MC68341

ADDENDUM TO MC68341 Integrated Processor User's Manual

April 19, 1995

Figure 3-12. M68300 Write Cycle timing

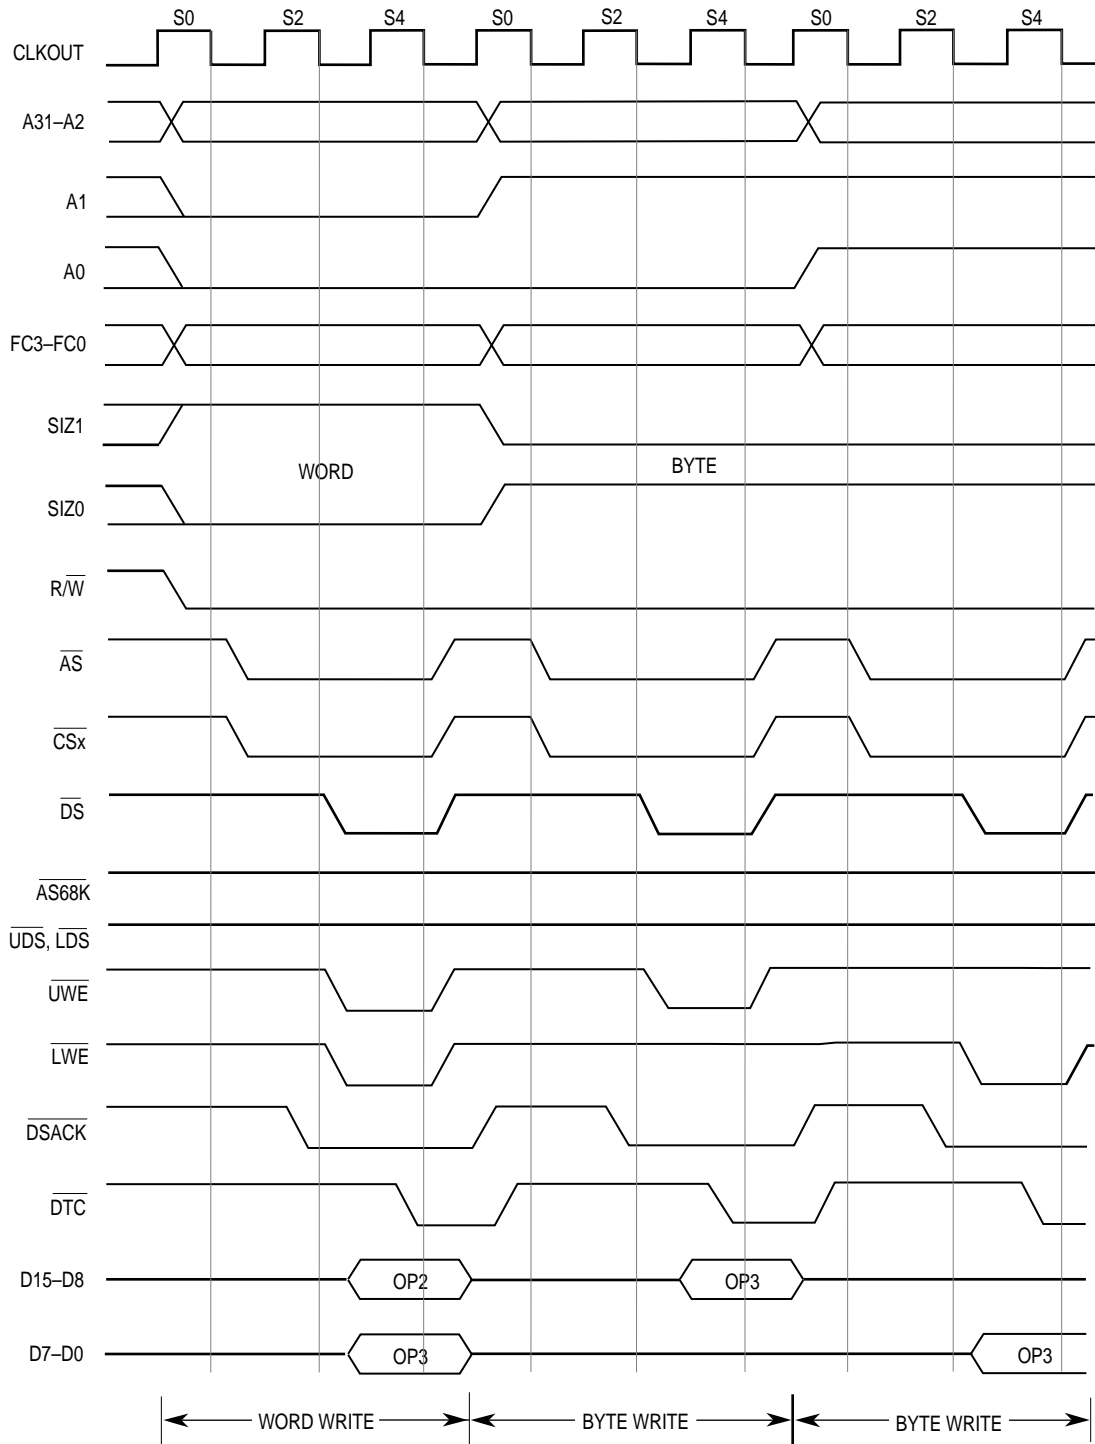
On page 3-25, the M68300 write cycle timing diagram (Figure 3-12) shows incorrect timing for \overline{DS} , \overline{UWE} , and \overline{LWE} . On page 3-28, the M68000 write cycle timing diagram (Figure 3-14) shows incorrect timing for $\overline{AS68K}$, \overline{CSx} , $\overline{UDS/LDS}$, and $\overline{UWE/LWE}$. Replace these figures with the following corrected figures.

Figure 11-2. Sample Crystal Circuit

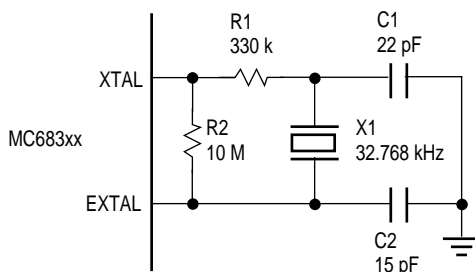
On page 11-2, Figure 11-2, a 10M resistor can be substituted for the 20M R2 bias resistor as shown below.

Figure 11-14. Circuit For Interfacing 8-Bit Device to 16-Bit Memory in Single-Address DMA Mode

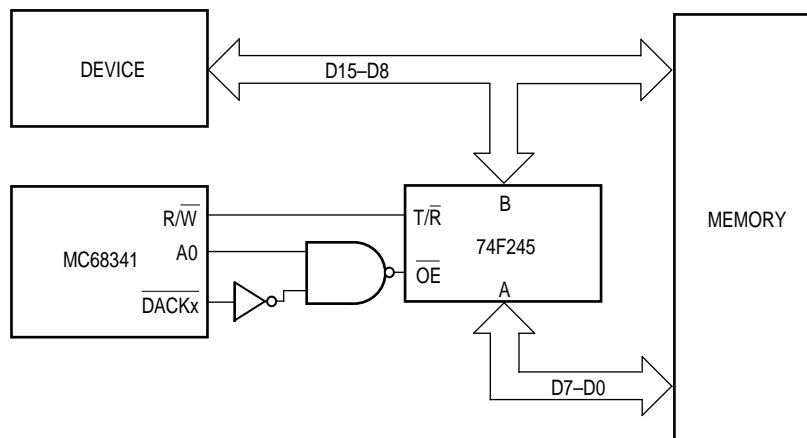
On page 11-10, the logic driving \overline{OE} on the 74F245 in Figure 11-14 should be corrected as shown below. Although not detailed, the byte enables for the memory block should be controlled during reads to prevent contention between the upper and lower bytes of the data bus when D7-D0 is muxed to the upper data byte.

80. Page 9-19,

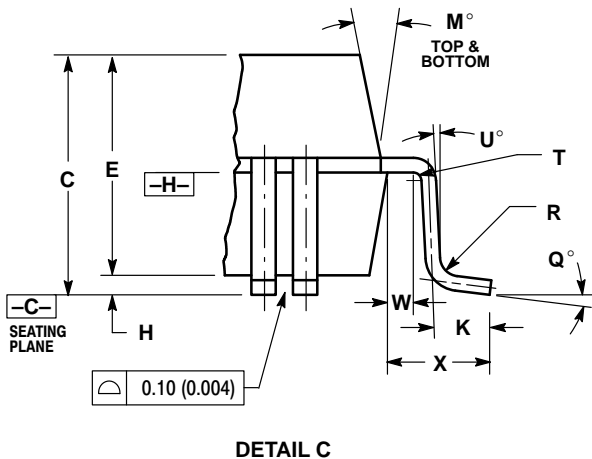
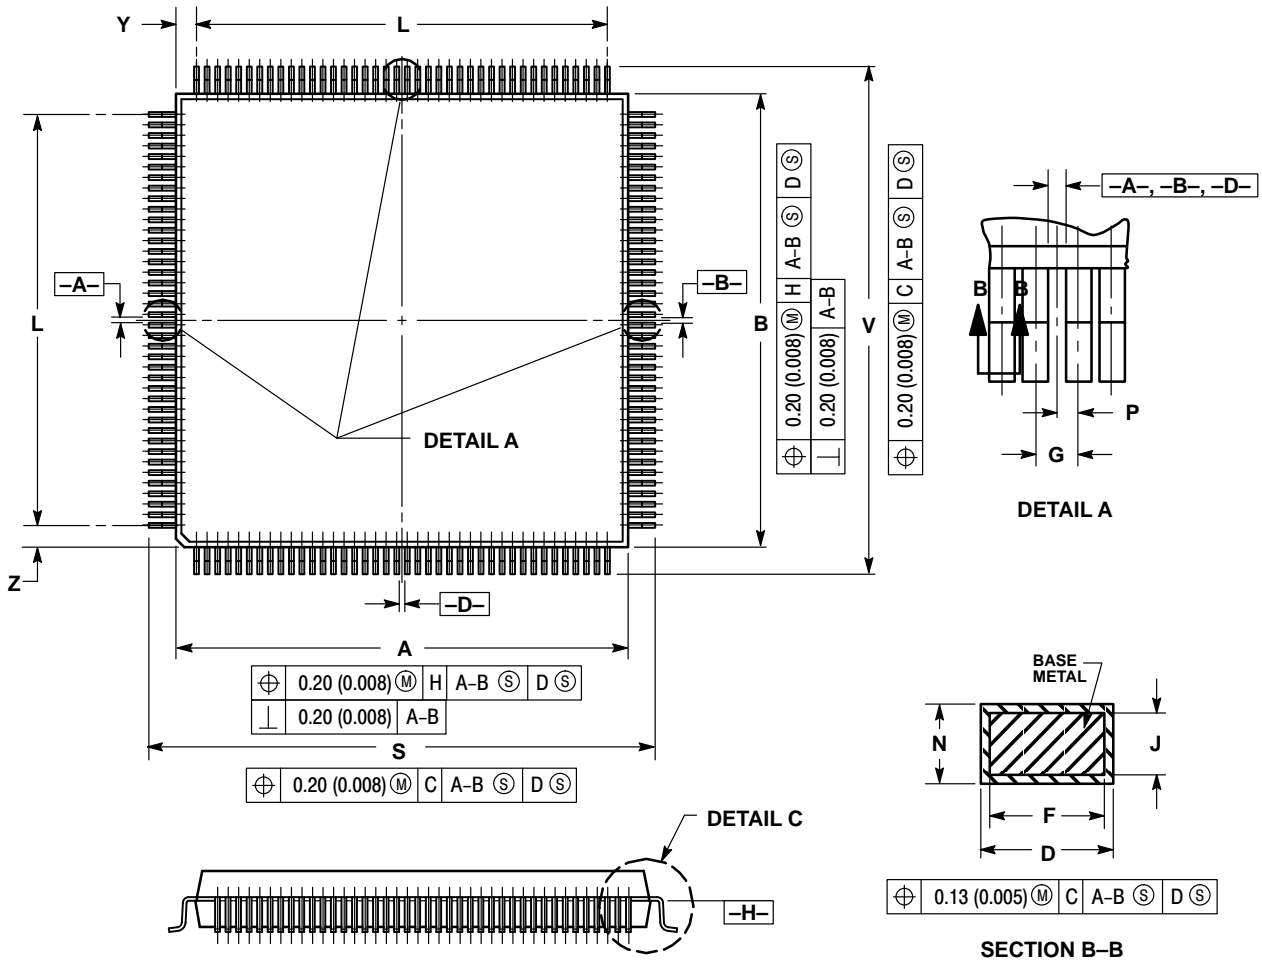
The timing diagrams reference as Figures 9-24 — 9-27 should be changes to 12-22–12-25.
